# Inspection/Audit Photos

Location Name: QB ENERGY OPERATING LLC PUCKETT 33C-25 (MESA 18) Pad

Location #: 335131

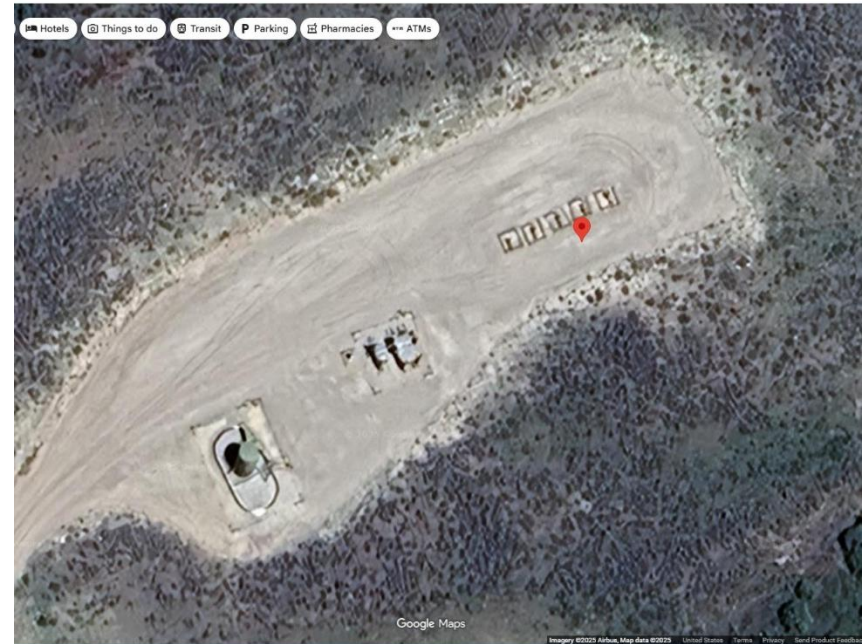
Photo # 4975 Scout Card records coordinates for the PUCKETT 33B-25D well - Coordinates appear to be off by approximately 19 ft (coordinates incorrect/not in compliance with CECMC Rules 216 & 414 –records require updating)

Photo # 4976 Scout Card records coordinates for the PUCKETT 33B-25D well - Coordinates appear to be off by approximately 19 ft (coordinates incorrect/not in compliance with CECMC Rules 216 & 414 –records require updating)

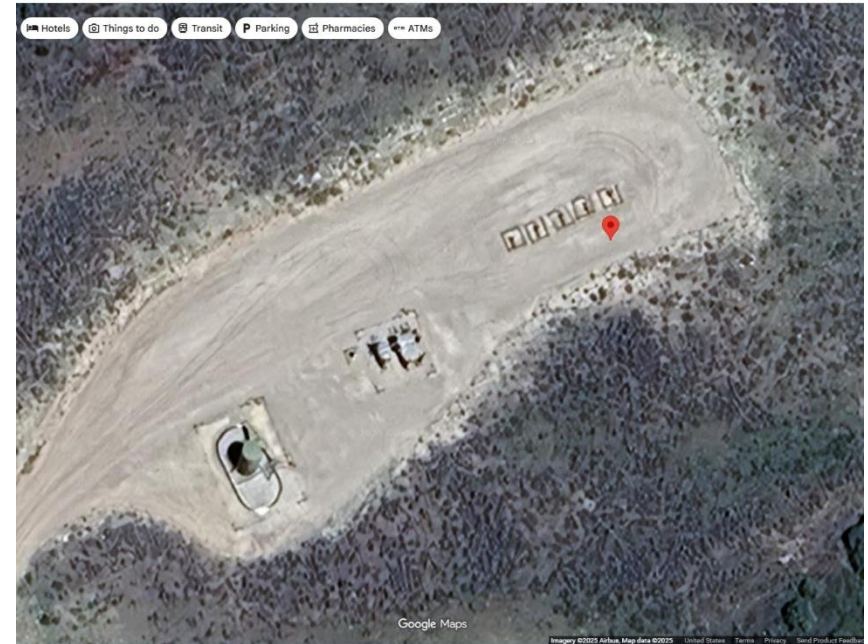
**Photo # 4977 Scout Card records coordinates for the PUCKETT 33A-25D well - Coordinates appear to be off by approximately 24 ft (coordinates incorrect/not in compliance with CECMC Rules 216 & 414 –records require updating)**

**Photo # 4978 Scout Card records coordinates for the PUCKETT 33A-25D well - Coordinates appear to be off by approximately 24 ft (coordinates incorrect/not in compliance with CECMC Rules 216 & 414 –records require updating)**
